9.7 OUTCOMES OF ADVERTISING: DRAFT PRECINCT STRUCTURE PLAN AND DRAFT PLACE PLAN - LEEDERVILLE; AND PREPARATION OF AMENDMENT 7 TO LOCAL PLANNING SCHEME NO. 2

1. **ADOPTS** Volume 04: Leederville Town Centre Place Plan included as Attachment 2;
2. **RECOMMENDS** that the Western Australian Planning Commission approve the modifications listed at Attachment 4 and the revised Leederville Precinct Structure Plan included as Attachment 5;

A detailed list of the amendments is included as **Attachment 4**. This schedule of modifications is a statutory requirement, separate to the summary of submissions. These modifications have been shown in tracked changes on **Attachment 5**.

Figure 4 - Cityscape Sub-Precinct requirements

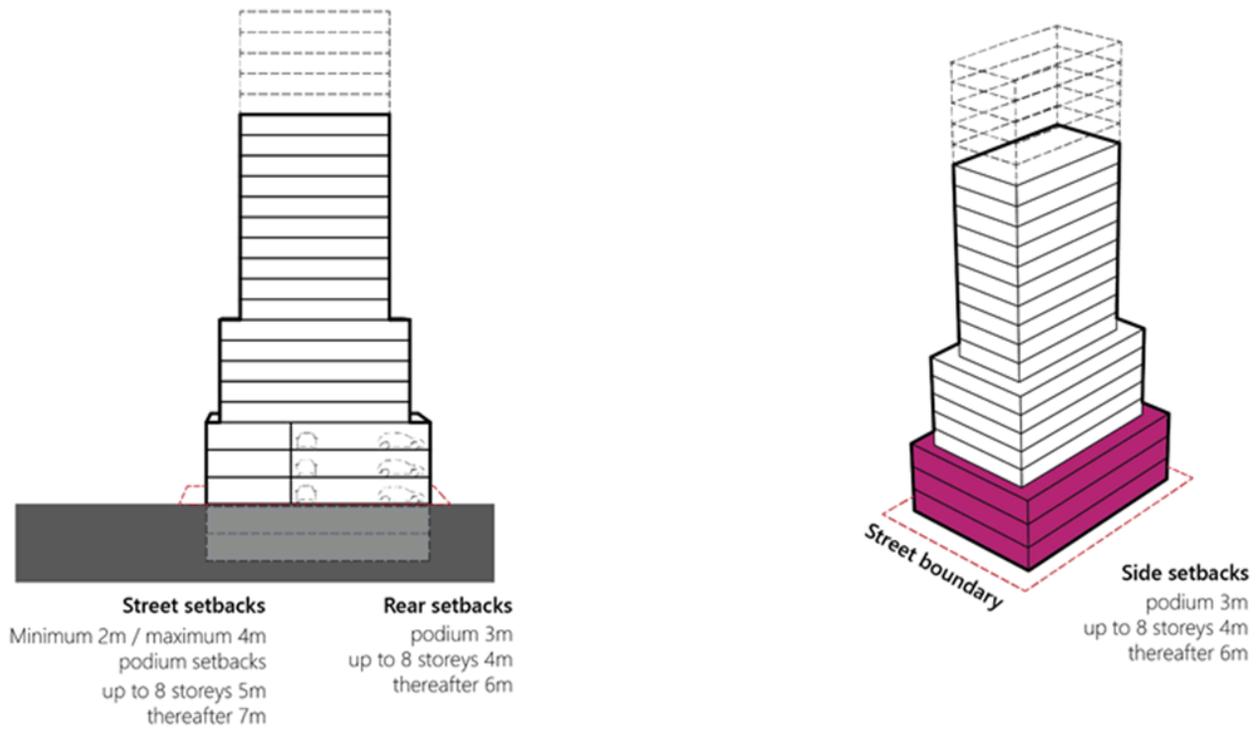
13.	Part 1, Clause 5.3	25	<p>Modify Part 1, Clause 5.3 as follows:</p> <ul style="list-style-type: none"> • Changing the terms 'maximum height' to 'Acceptable Height' and 'potential height' to 'Maximum Height'; <p>Modify clause 5.3.2 as follows:</p> <ul style="list-style-type: none"> • 46m <u>15.5m</u> <p>Modify clause 5.3.3 as follows:</p> <ul style="list-style-type: none"> • Changing the Maximum height outlined in the setbacks from '30m' to <u>29.5m</u> <p>Modify figure 4 by removing references to building height.</p>

Figure 6 - Urban Frame Type C Sub-Precinct requirements

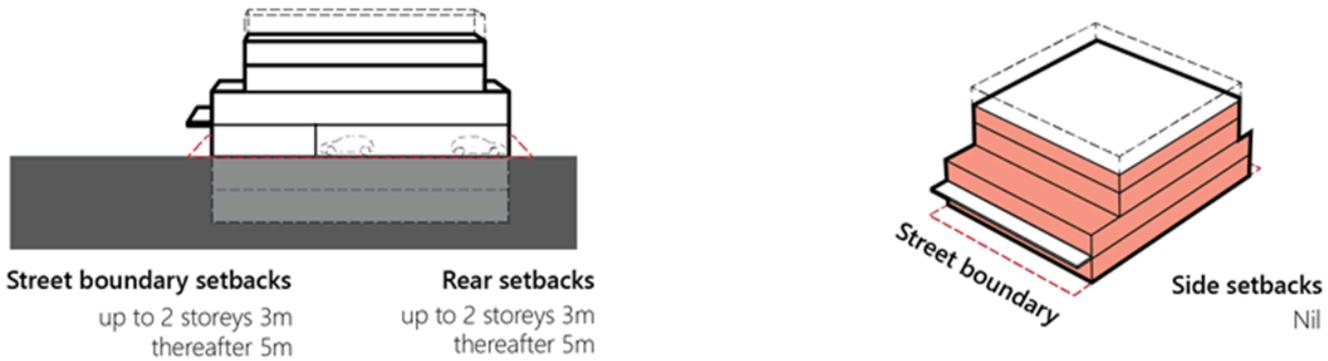
15.	Part 1, Clause 5.5	30	<p>Modify Part 1, Clause 5.5 to change:</p> <ul style="list-style-type: none"> • Changing the terms 'maximum height' to 'Acceptable Height' and 'potential height' to 'Maximum Height'; • 'Urban Frame Type C: Maximum Acceptable height 4 3 storeys (16m 12m). Potential additional Maximum height up to 5 (20m 19m) storeys in accordance with Clause 6.1'; and • Remove reference in figure 6 to building height.

Figure 19 - LPSP Precincts

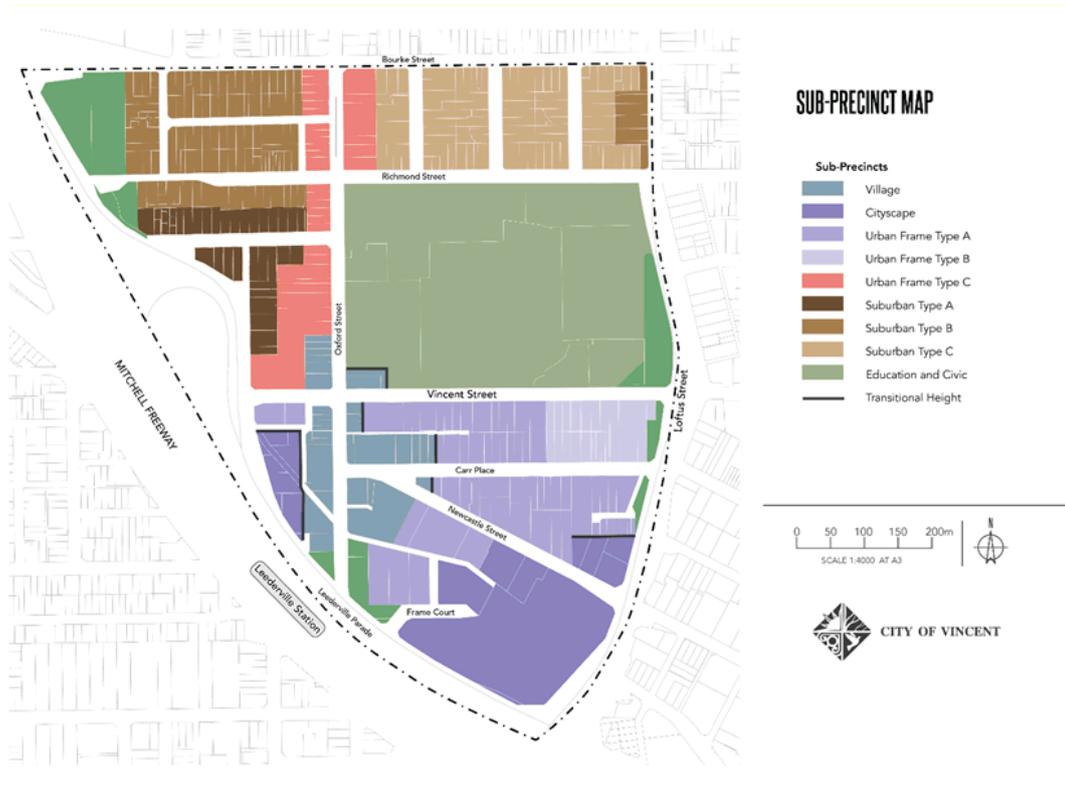
34.	Part 2, Clause 4.3.1	82	Replace figure 19 to reflect the sub-precinct in Plan 2.
35.	Part 2, Clause 4.3.3	83	Modify Part 2, Clause 4.3.3 as follows: 'development up to & <u>14</u> storeys'

Figure 31 - Key development sites

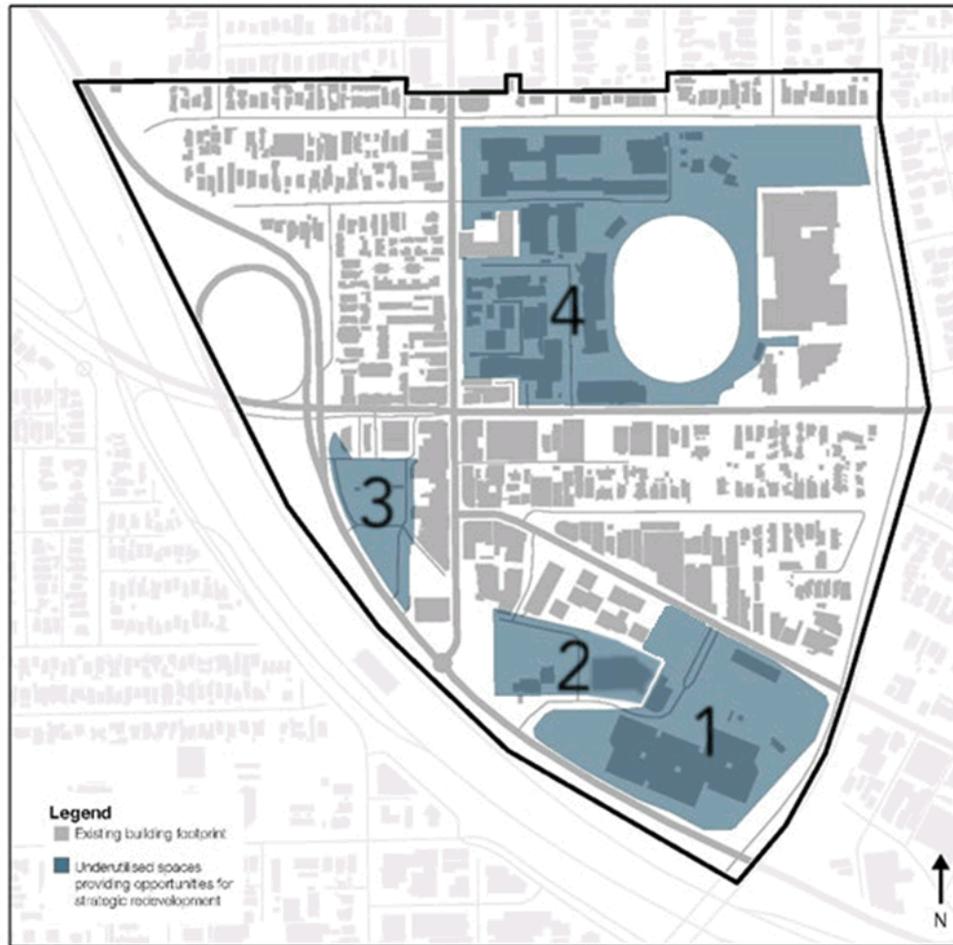
GENERAL - Administrative				
No.	Submitter Comment	Submitter	Administration Comment	Recommended Modification
71.	<p>The reference to a "Required Road" should be modified to "Formalised Public Thoroughfare".</p> <p>Figure 4 – Cityscape Sub Precinct: The podium primary setbacks shown in the massing diagrams and text do not correspond with the setback provisions in 5.3.2.</p> <p>4.3.6 Cityscape (Recommendations Table) Point 5 makes reference to Part 1 Clause 6.4 and 6.5, which do not exist. This should be reference to Part 1 Clause 5.4.5.</p> <p>5.2.2 - The discussion surrounding the Mounts Bay Main Drain should be under a heading called "Drainage".</p> <p>Figure 31 – Key Development Sites should align with the lot boundaries.</p>	25	<p>Noted and agreed.</p> <p>Amend diagrams, plan 1 and plan 2 to match the provisions.</p> <p>Noted and agreed.</p> <p>Noted and agreed.</p> <p>The key developments sites should match the landholdings.</p>	<p>Modify the wording of Plan 1 – Structure Plan Map:</p> <p>Amending "Required Road" to "Formalised Public Thoroughfare".</p> <p>Align Part 1 diagrams, plans and provisions.</p> <p>Modify Part 2, Clause 4.3.6, Recommendation 7 as follows: 'Part 12 Clause 5.4.5 6.4 & 6.5 Part 1 5.1.2c'</p> <p>Modify Part 2, Clause 5.2.2 as follows: New heading of 'Drainage' to describe the Mounts Bay Drain.</p> <p>Modify Part 2, Figure 31 to align with the lot boundaries.</p>

41.	Part 2, Clause 5.4.5	132	Update figure 31 to amend the boundary of key development site 1, 629 Newcastle Street, to include the north-west lot 51.
42.	Part 2, Clause 5.5.5	148	Modify Part 2, Clause 5.5.5, Recommendation 1 as follows: ' Enable the staged delivery of the Mounts Bay Main Drain green linkage <u>Pedestrian Linkage</u> '.
